Volvo Chassis - Air Leak At Wet Tank - Model VNL

QJ 1-12337163670

Fitting -	Global Fitting - 991083 / 991965
20999390	Global Fitting - 99 1083 / 99 1903

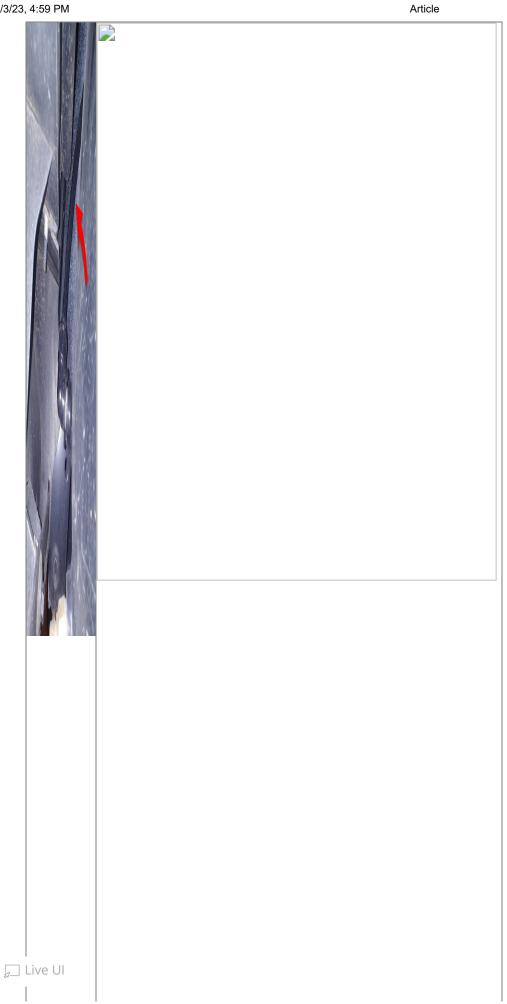
Volvo VN models have been reported having the wet tank, located on the front (outside) side of the wet tank, air line rub the chassis fairing. If the truck was built starting March 11, 2019 with air tank 22945941 and air fittings 991083 or 991965, in the front port of the air tank, this issue is possible. To correct this issue, replace fittings 991083 or 991965 with fitting 20999390.

QJ Solution: Proposed solution is to S-Note the old metric fitting onto about 95 trucks. Plan is to use the S-Notes until the end of spec week 20W16 (no longer needed starting 20W17).
